-LIGO-

Document Type	DCC Number T080111-00-C	May 5, 2008
UK Satellite Amplifier Pre-Production Prototype Bench Test and Evaluation		
J. Heefner, T. Etzel

This test report documents the bench test results and evaluation of the AdL Suspension Satellite Amplifier supplied as a pre-production prototype by the University of Birmingham. Bench tests were conducted in accordance with LIGO document number T080062-00-C, “AdL UK Satellite Amplifier Pre-Production Test Plan”. A link to the completed test plan with results is included in Appendix A of this document. The design requirements for the Top Driver can be found in LIGO document number T060067-00-C, “AdL Quad Suspension UK Coil Driver Design Requirements”.

Figure 1: Satellite Amplifier Box Top Cover

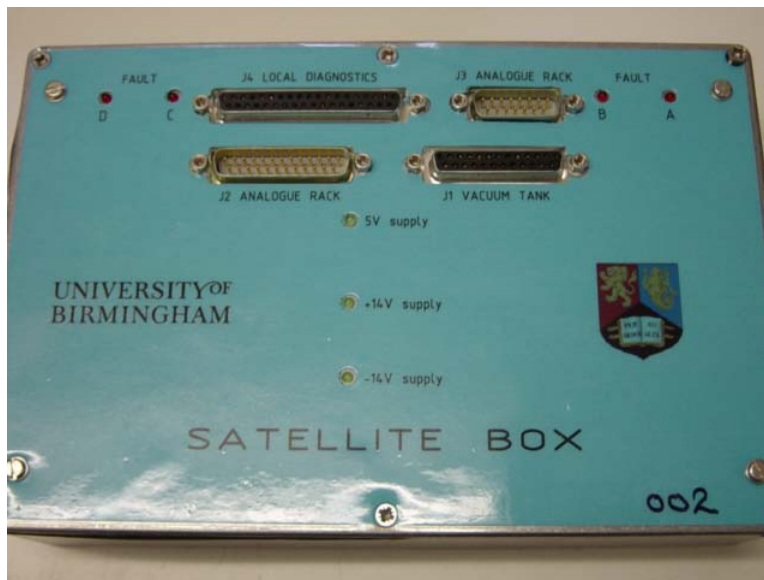
As can be seen from the first photo (Figure 1), all connectors and indicators are labeled. The serial number of the unit is also written on the cover. For the full production units, the drawing number associated with the chassis assembly drawing should also be added to front or rear panel labels.

Power indicators are included on the top cover and should be maintained in the production design.

Figure 3: Closer view of Satellite Amplifier Circuit Board

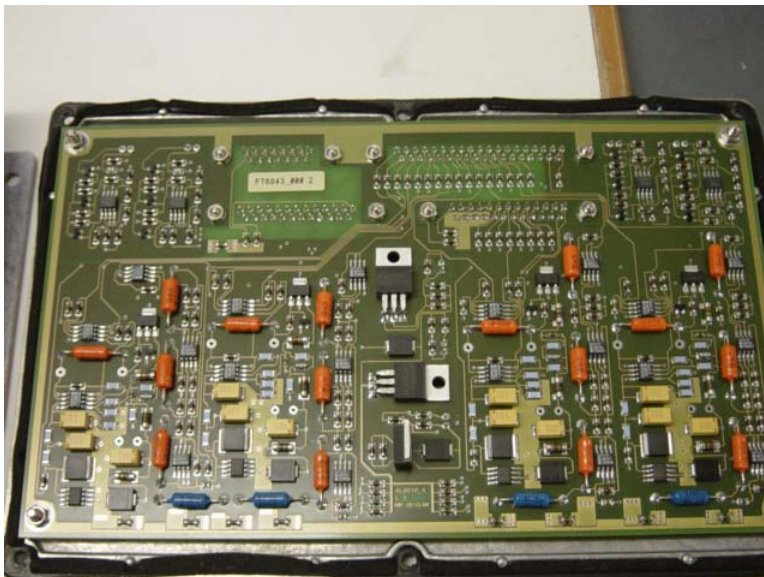
The circuit board provided as the pre-production version did not include a silkscreen layer, but the silkscreen layer was provided on a paper printout with the boards. Lack of a silkscreen layer or some means of identifying components on the board other than the paper copy made evaluation, checkout and debug of the unit extremely difficult. The silkscreen layer must be included in the full production units.

Trace widths on the board appear to be 10-12 mils. Although this may be adequate, it is recommended that these widths be increased to a minimum of 15mils (0.381 mm). This will increase the reliability of the units as modifications and repairs are made over the life of the amplifiers.

The regulators used in the design are not tied to the circuit board and there is no thermal pad on the circuit board for the regulator tab. Adequate thermal pads, heatsinking and mounting hardware need to be included in the production units.
